Access Compliance Report

Public Rights-of-Way

(Curb Ramps)

Intersection ID: 10471	Main Street: CALLAHAN_ST	Cross Street: STATESVILLE_AV	Location: SW
ADA ID: 1E47DDAE11D2	Ramp Type: PerpDiag	Initial Pass/Fail: Fail	Overall Compliance: No
		Severity Score: 10

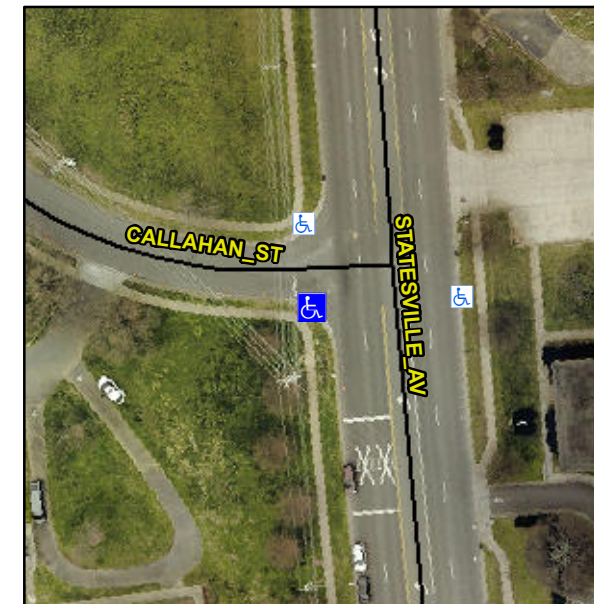
Not Found, R304.5.1, R304.5.3

Compliance	Description	Data	Compliance	Description	Data
N/A	Ramp Length (in)	60.0	Yes	Ramp Slope (%)	5.5
No	Ramp Width (in)	47.0	No	Ramp XSlope (%)	2.4
N/A	Flare Type LT	N/A	N/A	Flare Type RT	N/A
N/A	Flare Slope LT (%)	N/A	N/A	Flare Slope RT (%)	N/A
N/A	Flare Traversable LT?	N/A	N/A	Flare Traversable RT?	N/A
N/A	Landing Length (in)	N/A	N/A	DWS Provided?	N/A
N/A	Landing Width (in)	N/A	N/A	DWS Contrast?	N/A
N/A	Landing Slope (%)	N/A	N/A	DWS Length (in)	N/A
N/A	Landing X Slope (%)	N/A	N/A	DWS Full Width?	N/A
N/A	Landing Curb? (Y/N)	N/A	N/A	DWS Offset (in)	N/A
N/A	Shared Landing?	N/A			
N/A	Gutter Ponding?	N/A	N/A	Gutter Slope (%)	N/A
N/A	Gutter Lip Ht (in)	N/A	N/A	Gutter X Slope (%)	N/A
N/A	Painted X Walk1?	No	N/A	Painted X Walk2?	No
	X Walk 1 Direction	To E		X Walk 2 Direction	To N
N/A	X Walk 1 Width (in)	N/A	N/A	X Walk 2 Width (in)	N/A
	X Walk 1 Slope (%)	0.7		X Walk 2 Slope (%)	0.7
	X Walk 1 X Slope (%)	1.0		X Walk 2 X Slope (%)	0.8

Remove & Replace Curb Ramp With Two New Directional Ramps or Equivalent.
